Product Change Notice (PCN)

PCN Number: PCN-0455011R-01

Product(s) Affected: *SJ-3523-SMT-TR & SJ-3524-SMT-TR*

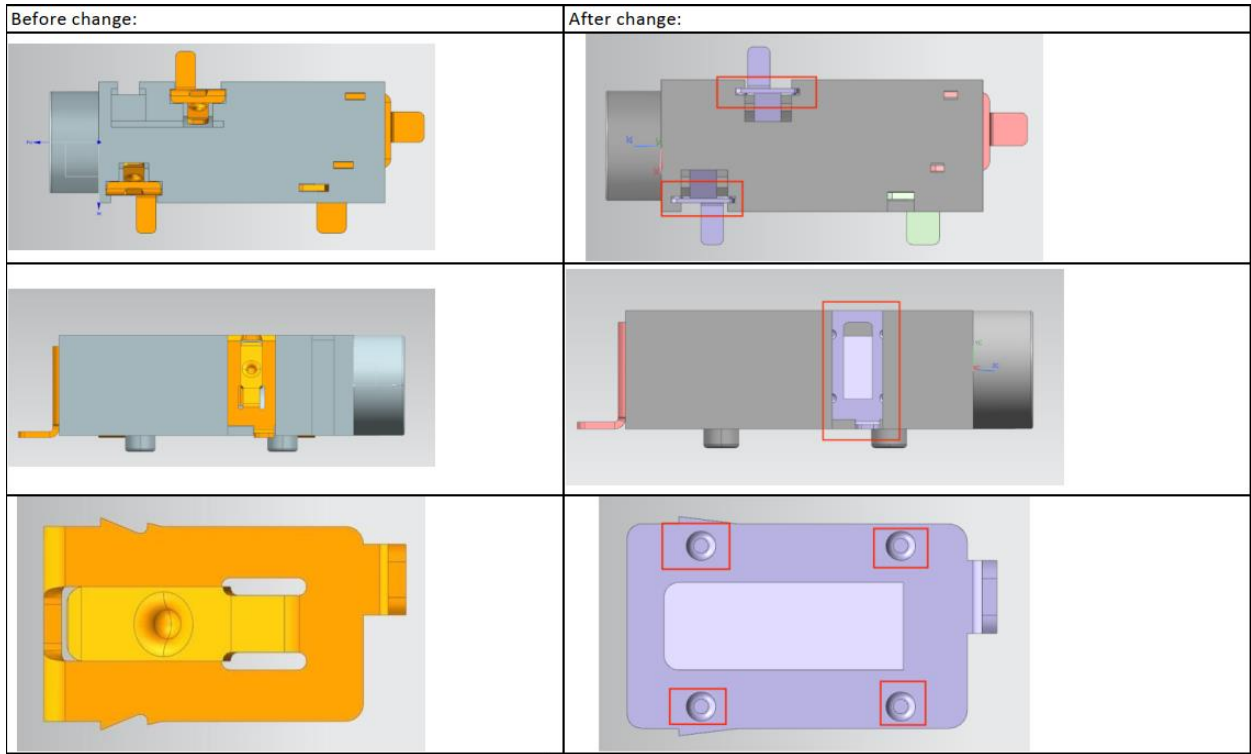
- 1) Removal of additional slots in the base. Plastic structural change.
- 2) Hardware/Shielding adjustment.
- 3) Terminal 4 material change to Brass.

No Change to PCB Footprint

See image below for reference and check Same Sky website for updated drawing on or after **12/10/2024**. Cosmetic differences may be visible due to new molds and not affect the form fit and function of the product.
